Notice of Meeting
Polk City | Planning and Zoning Commission (P&Z)

October 16, 2023 | 6:00 pm
City Hall | Council Chambers

SITE PLAN AMENDMENT REVIEW

Project: Home State Bank Site Plan
 Amendment

1 DUMPSTER & GENERATOR PLAN
SCALE: 3/16" = 1'-0"

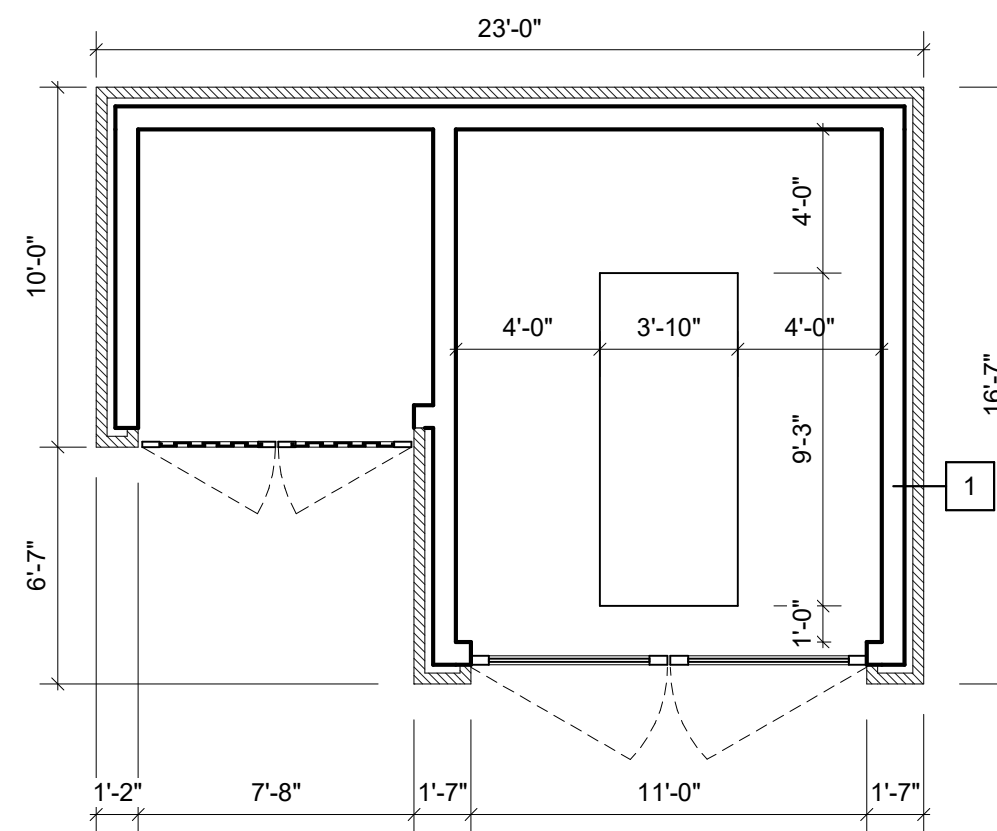
In addition to the monument sign, Home State Bank is proposing an expanded trash enclosure to house a generator that will service the proposed building. The expansion to the trash enclosure will be constructed using materials similar to the originally proposed trash enclosure and will be constructed contiguous to the proposed trash enclosure.

3 ELEVATION - SIGN

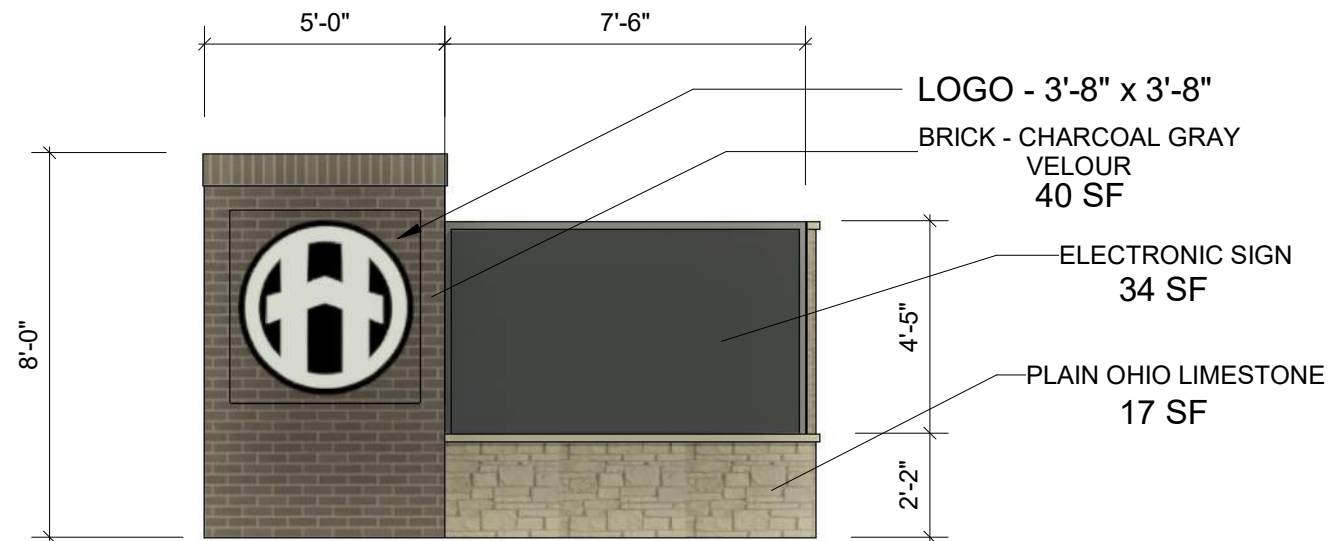
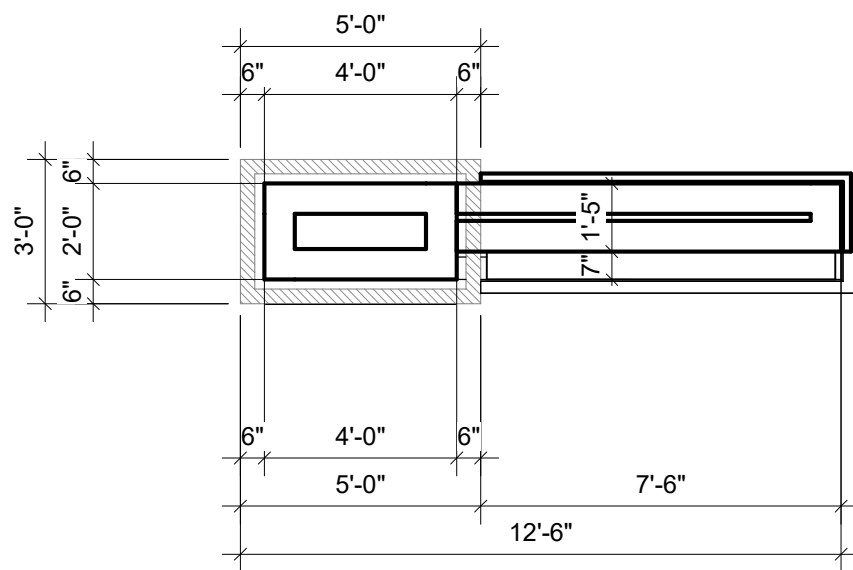
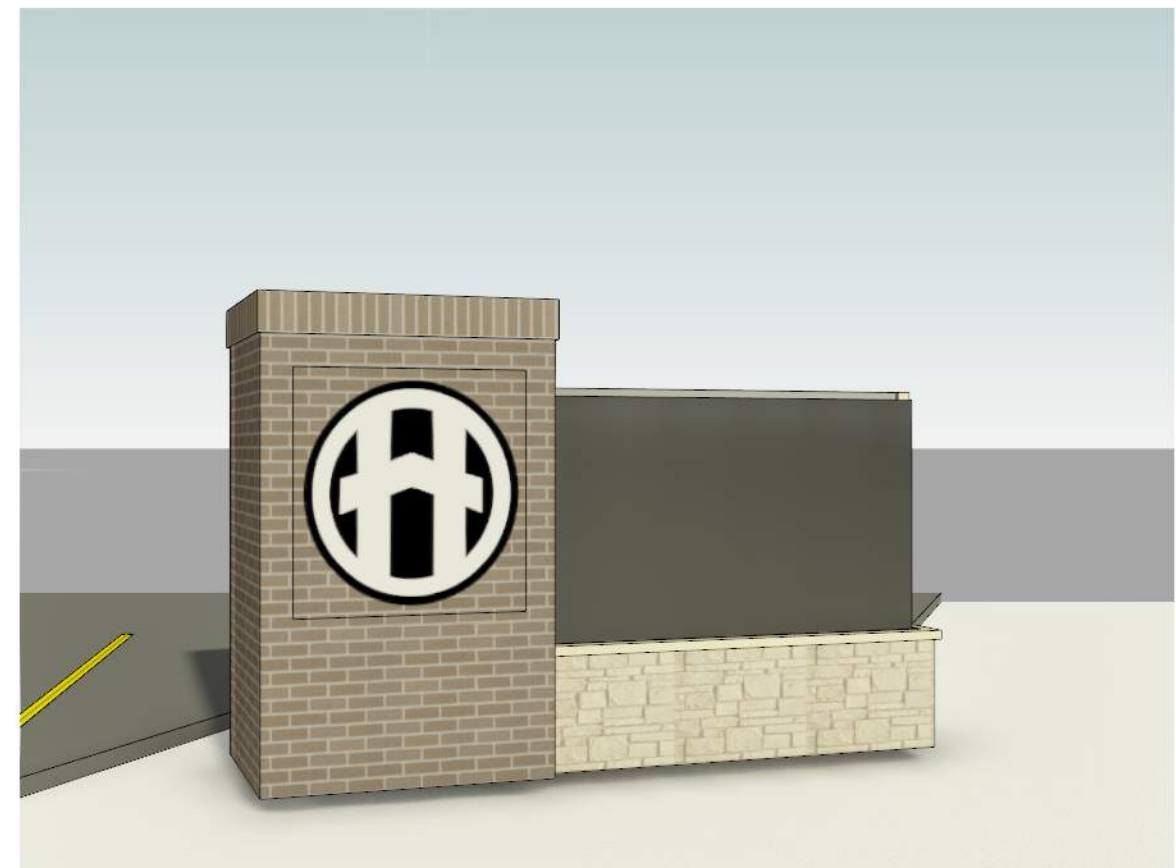
No monument sign was proposed as part of the original site plan. As part of this site plan amendment, Home State Bank is now proposing construction of a monument sign, with an electronic board, that will face the intersection of S. 3rd Street & Bridge Road.

- THE PROPERTY OWNER SHALL BE RESPONSIBLE FOR REDUCING LIGHTING INTENSITY OR MAKING OTHER ADJUSTMENTS TO MINIMIZE THE INTRUSIVENESS OF THE MONUMENT SIGN TO A LEVEL ACCEPTABLE BY THE CITY MANAGER IN ACCORDANCE WITH CHAPTER 166.18.

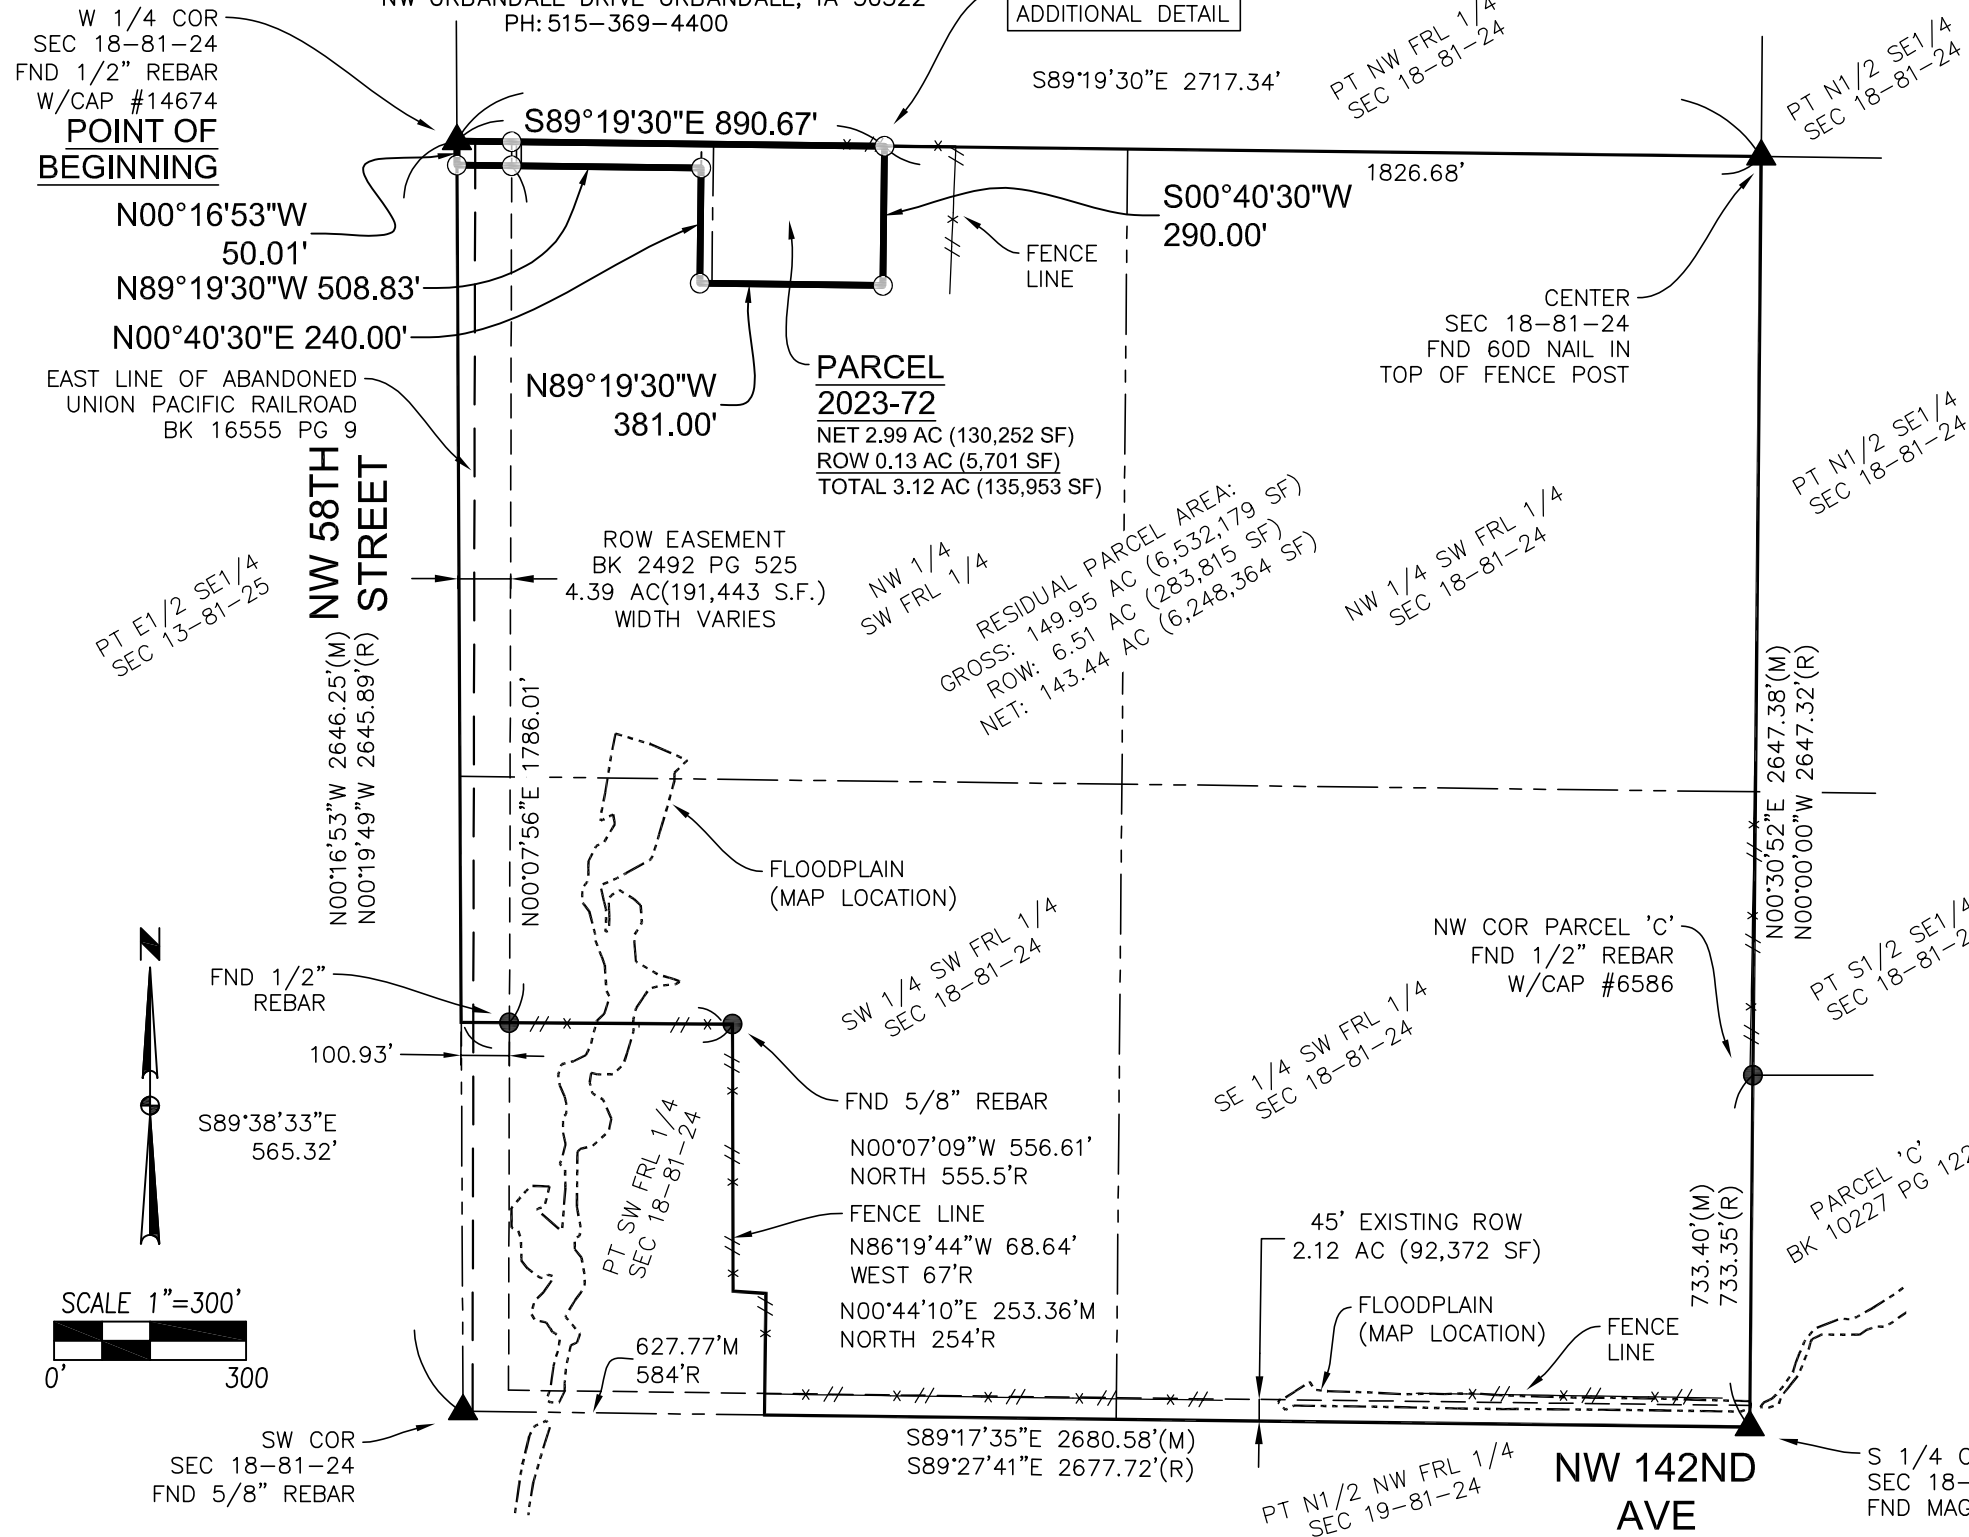
1. Per the Subdivision Regulations, Parcel 2023-72 will be responsible for their share of the cost of constructing an 8" water main along NW 58th Street. The property owner will be required to sign a Development Agreement for Parcel 2023-72 that allows the city to construct a water main and assess the property for their share of the cost based one-half the cost of an 8" watermain for their 50' of front footage to NW 58th Street. The City will provide the document for the property owner's signature prior to this item being placed on the Council agenda. A similar agreement will be required for the residual parcel at the time that outlot is further developed.

2. Per the Subdivision Regulations, Parcel 2023-72 is required to construct a public 5' sidewalk along NW 58th Street. The property owner will be required to sign an Agreement to Install Sidewalk that allows the sidewalk to be deferred until the parcel is annexed and the City deems it the appropriate time for the sidewalk to be constructed. The Agreement requires the property owner to install the sidewalk upon written notice and, should the property owner fail to perform, allows the city to construct this sidewalk and assess the property for its cost. The City will provide the document for the property owner's signature prior to this item being placed on the Council agenda. A similar agreement will be required for the residual parcel at the time it is further developed.

- a. The Subdivision Regulations would require this parcel to be split via a Minor Plat of Subdivision since the parcel has already been split, however Polk County has agreed to allow this parcel to be split via Plat of Survey.

- b. Per Polk City's Subdivision Regulations (Section 170.08-4-H), the division of land into a flag lot or lots shall generally be discouraged by the City; and only permitted to provide access to lots where there exists unique topography, an unusual configuration of land ownership, adjoining developed land will not allow access from a public street, public land or environmentally sensitive land that is planned to be left undisturbed, or to minimize streets or public infrastructure to reduce maintenance responsibilities.

- c. Polk City subdivision regulations require the developer to provide hydrant coverage per City Fire Code (250' radii).
2. A Development Agreement for future water main along NW 58th Street will need to be signed by the property owner prior to Plat of Survey approval. The City Clerk will record this document and the developer shall be responsible for the cost of recording.

- The subject property is located outside the Polk City and a Rural Plat of Survey is what Polk County Planning and Zoning Department is requesting be prepared for the proposed division. The proposed division is consistent with Polk County's subdivision and zoning ordinance. We would request the City waive their requirement of a Minor Plat of Subdivision be prepared.

- The Polk City subdivision regulations require a developer provide hydrant coverage. The subject property is not within Polk City and no municipal water is available. We would request the City waive the requirement of hydrant coverage.
